Memorandum Department of Planning & Public Works

RE: **P.Z. 47-2007 Conway Point Office Building (Conway Partners, LLC):** A request for an ordinance amendment to amend the legal description, permitted uses, and development criteria for the 1.063 acre parcel of land, zoned "PC" Planned Commercial District, located at 15310 Conway Road, at the southeast corner of the intersection of Chesterfield Parkway and Conway Road.

Planning Commission Staff Report

Meeting Date: March 10, 2008
From: Jennifer Yackley, Project Planner
Subject: Ordinance Amendment Vote Report
Location: 15310 Conway Road
Petition: P.Z. 47-2007 Conway Point Office Building (Conway Partners, LLC)

SHEET:
 TREE STAND
 DELINEATION
TSD - 1.0
 PROJECT NO.
 08-043
 DATE
 01/12/08
 DRAWN BY: LFC
 REVIEWED BY: JM

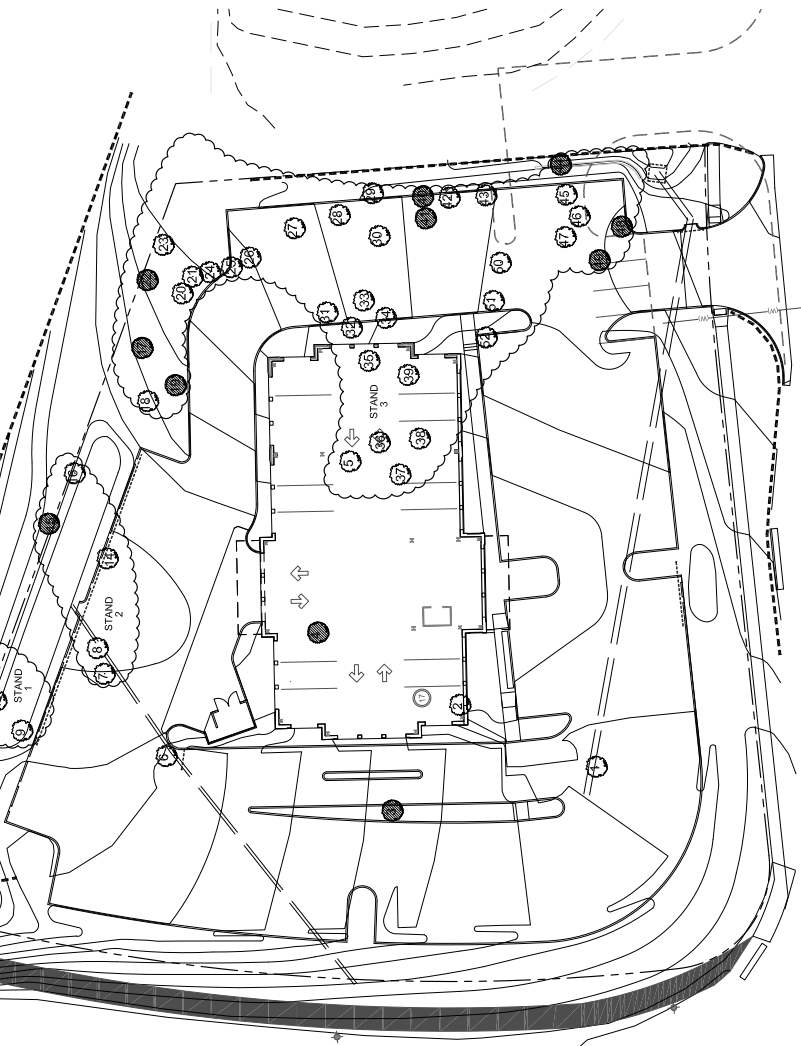
10. Please be advised that the development does not meet the landscape requirements of the Tree Manual. If you choose to seek a variance

please provide a separate letter addressing each variance you are requesting to be reviewed by the Department of Planning and Public Works. Include why each variance is needed and what is being proposed in the alternative; a preliminary landscape plan should also be included. The preliminary plan does not meet the following landscape requirements:

ANSWER: A variance request has been submitted to staff for review and comment.
